Proposal for Constellation Re-arrangement in IR HARQ

IEEE C802.16m-09/0124r2

Target section: 11.13.2.2 Bit re-arrangement

Problem of Current Co-Re Operation

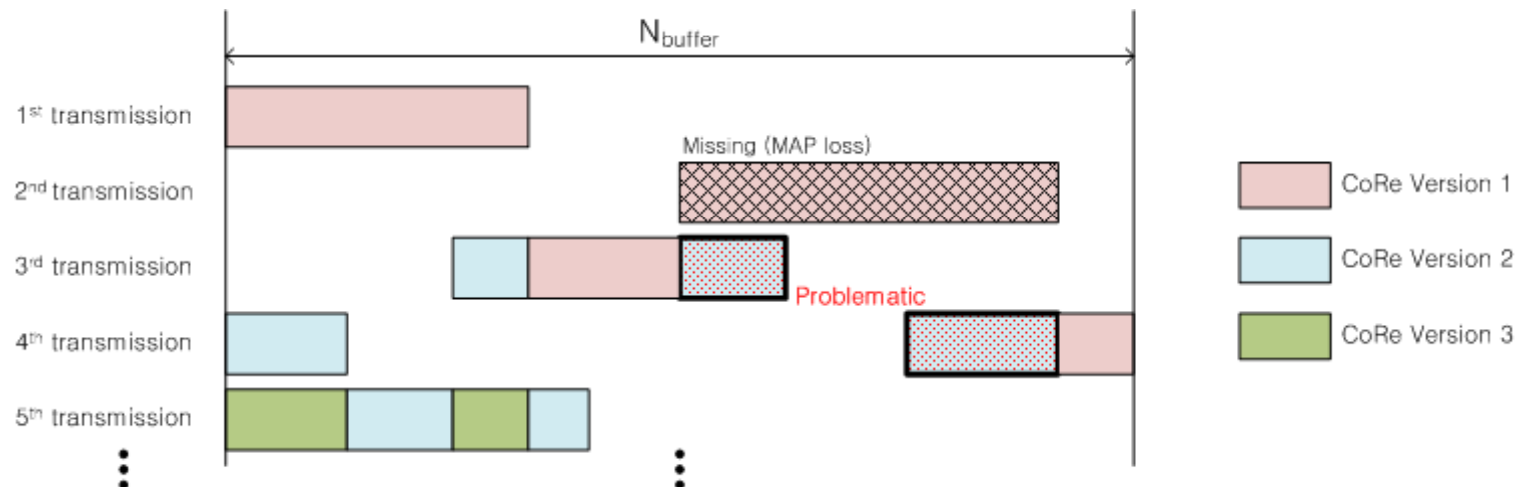
- Current Co-Re operation has a problem in case of IR-HARQ and adaptive HARQ.
 - If the MAP is missing, the MS can't know the CoRe-version for each transmitted bit.
 - In IR and adaptive HARQ operation, this problem is critical.
 - For each transmitted symbol, the CoRe-version may be indicated, but the overhead is large.

Proposed Co-Re Operation

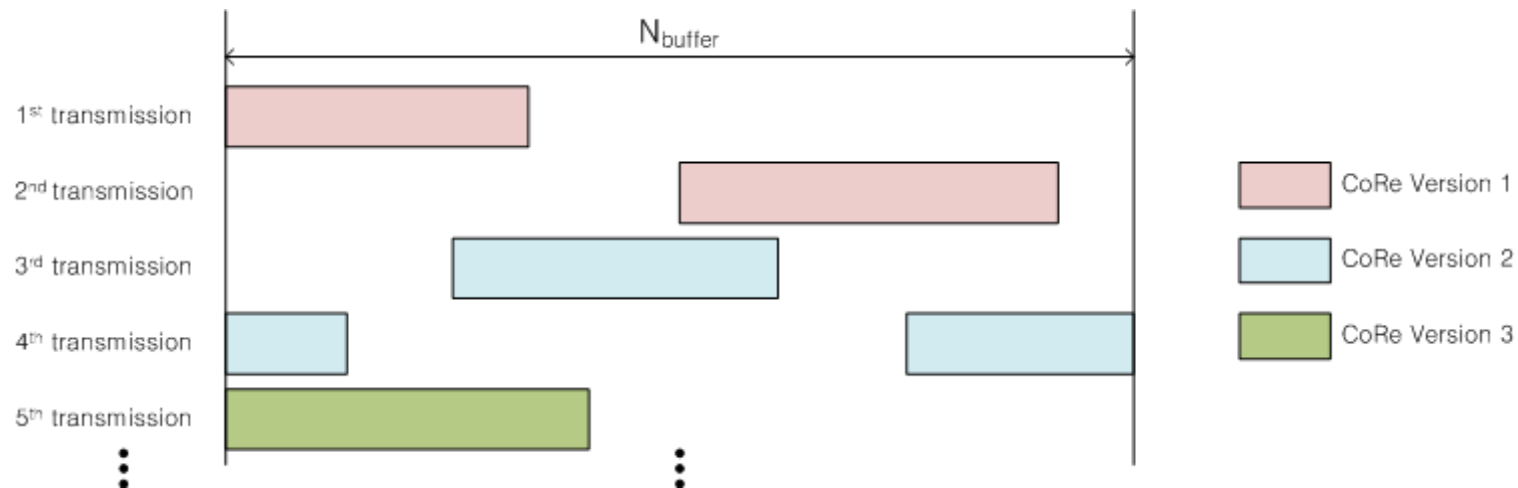
- In the proposed scheme, all the modulated symbols in a HARQ re-transmission use same CoRe-version.
 - Robust Co-Re operation in case of MAP loss
 - Minimal overhead for CoRe operation

All the QAM symbols in the same HARQ re-transmission use same Co-Re version.
The specific ~

~~For each transmitted burst, the BitRe version is selected by the transmission number of this burst.~~ All the QAM symbols in the same HARQ re-transmission use same BitRe version. The specific ~
